## **APPENDIX B: NOP AND RESPONSES**

## Bob Jones Path - SLO to Ontario Road

**Document Type:** NOP - Notice of Preparation

**Project Lead Agency:** San Luis Obispo County

DETAIL 6

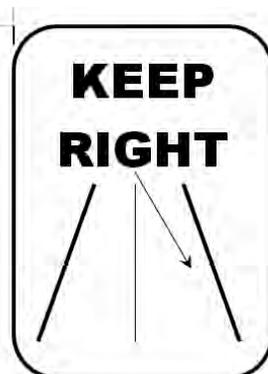
Detail 6 implies that horses will be allowed. Horses should not be allowed. The difficulty of keeping the trail clean would be greatly compounded with the presence of horses.

One proposed sign states "ALL DOGS MUST BE ON LEASH." I ride the trail from San Luis Bay Drive to Avila Beach every day. Some leashes are long enough to preclude control of the dog. The sign should require dogs to be on a short leash with short being 3 feet or less.

AC Curb Detail 9

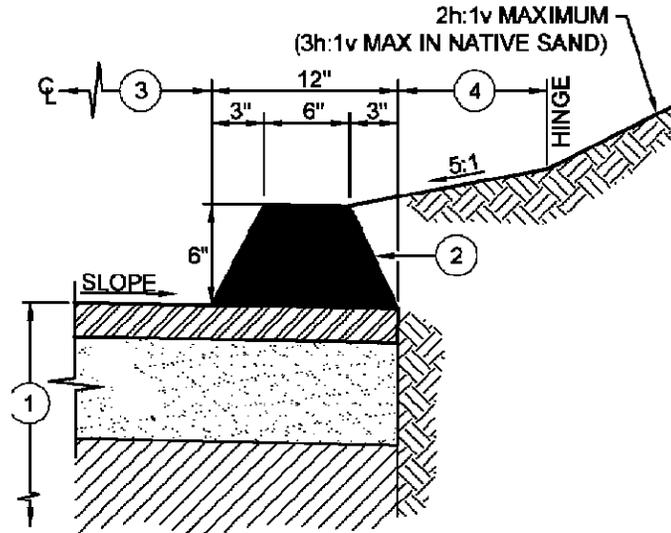
DETAILS Page 4 of 6 shows a detail of the curb and adjacent slope. With this configuration the first rain will cover the trail in mud. The slope should terminate at the curb well below the top of the curb.
